Attachment Booklet

1. Reasons for Refusal

**Re: Proposed Development / Controlled Activity Approval
41 Greendale Road Bringelly Lot 5 DP252040 – Re-Advertising of amended
proposal site for cementery**

ITEM NO:	PLAN 02	FILE NO:	
SUBJECT:	CEMETERIES AND CREMATORIUM WITHIN GREENDALE AND BRINGELLY - CUMULATIVE TRAFFIC IMPACTS AND RU1 PRIMARY PRODUCTION ZONE OBJECTIVES		
COMMUNITY STRATEGIC PLAN REFERENCE:	THE COMMUNITY IS SUPPORTED BY A WELL MANAGED AND RESPONSIVE COUNCIL

master plan 04

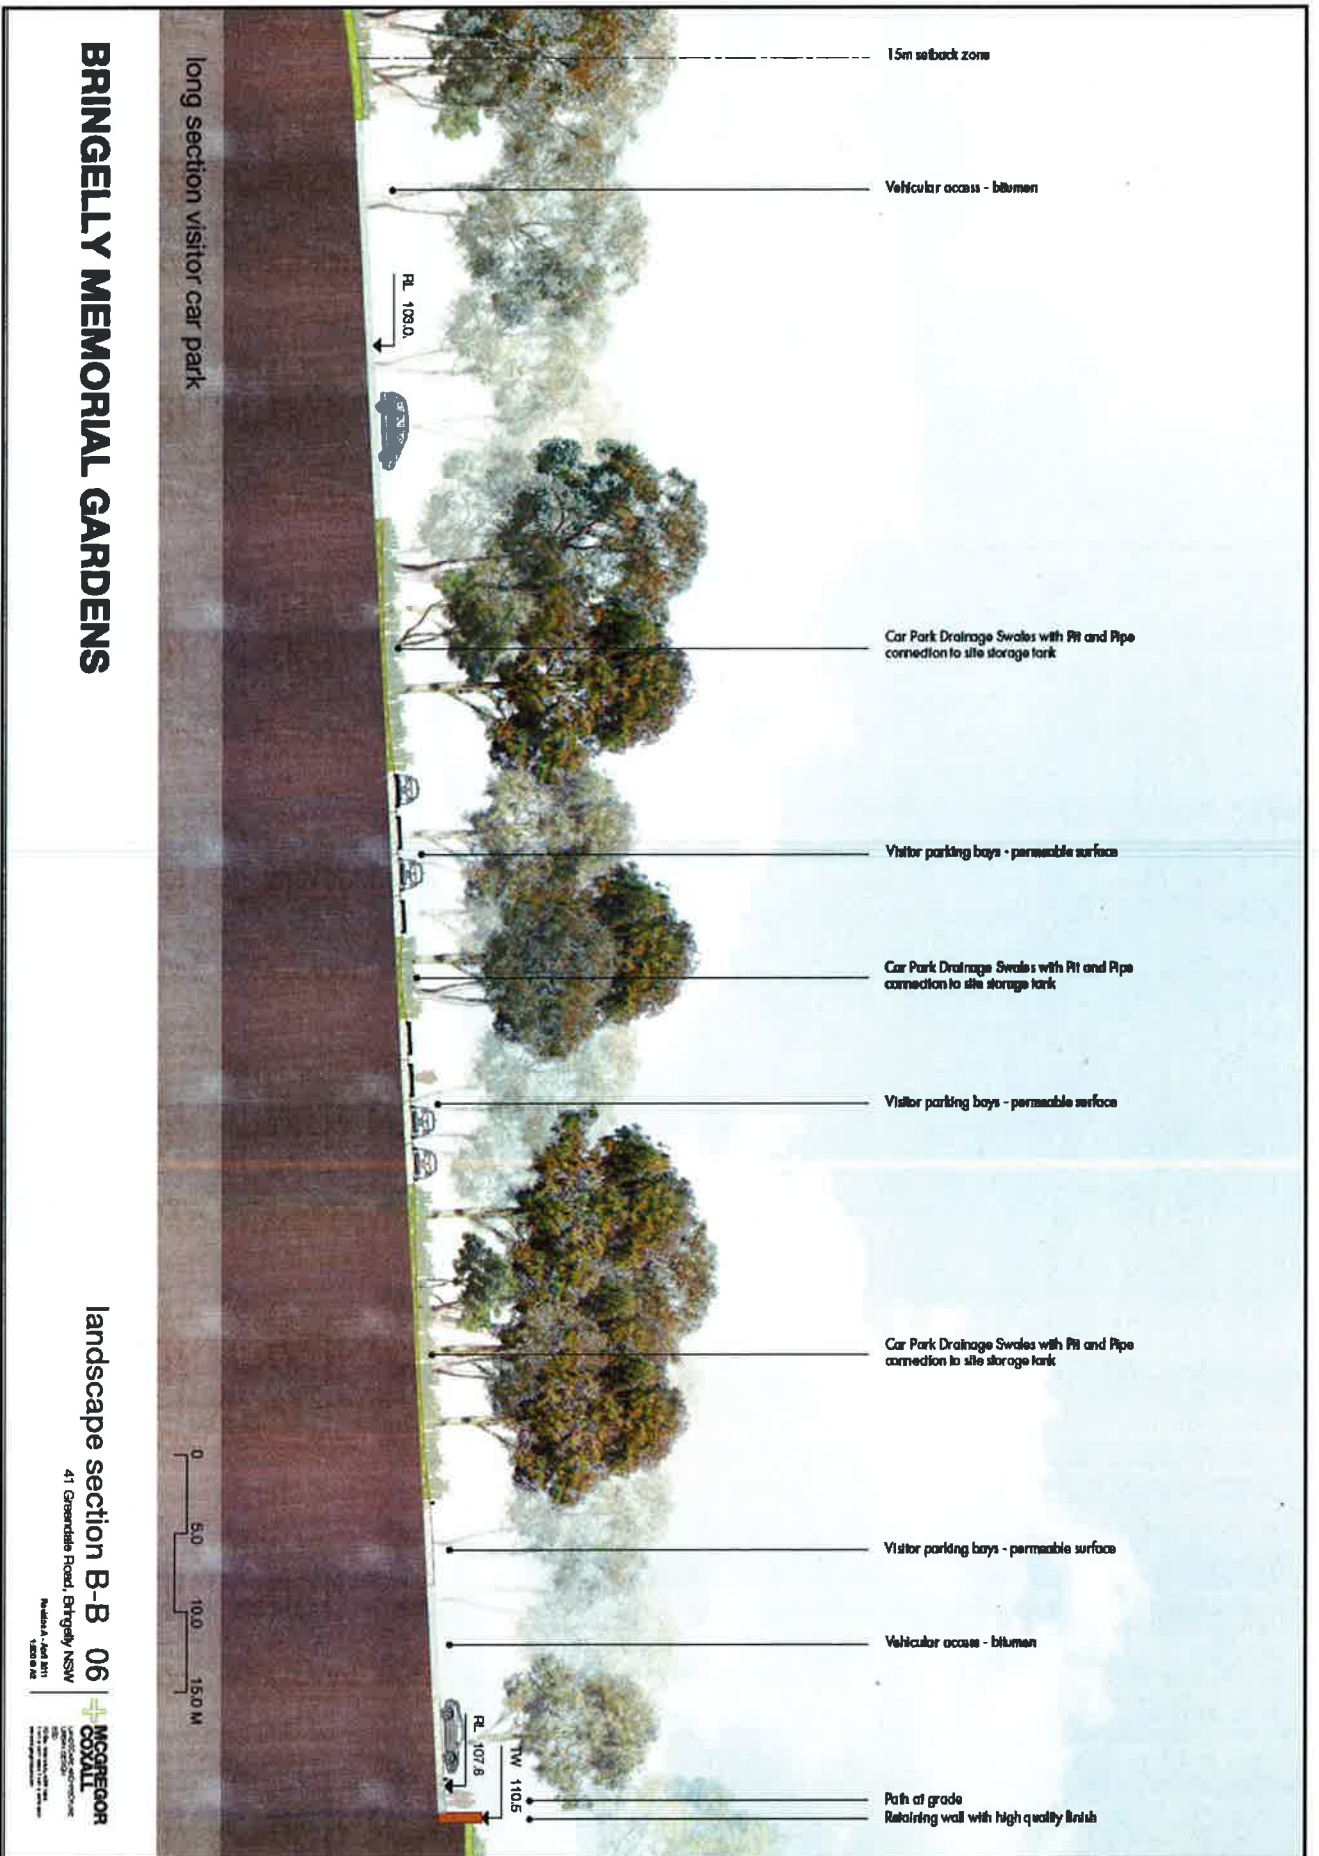
- (ii) Proposes that part of the proposed effluent disposal area and over flow on-site parking is to be located within the landscape buffer zone.
5. Pursuant to the provisions of S79C(1)(b) of the Environmental Planning and Assessment Act 1979, the proposed staged nature of the development does not enable a proper assessment of the proposed buildings and structures as they are the subject of a future Development Application yet are considered integral to the cemetery operations and consequently Council is unable to consider all likely impacts upon the natural and built environment.

6. Pursuant to the provisions of S79C(1)(b) of the Environmental Planning and Assessment Act 1979, the design and restriction of onsite parking to the entrance of the site will result in unacceptable operational and accessibility impacts for visitors making it difficult to access facilities and potentially lead to congestion impacts on Greendale Road.
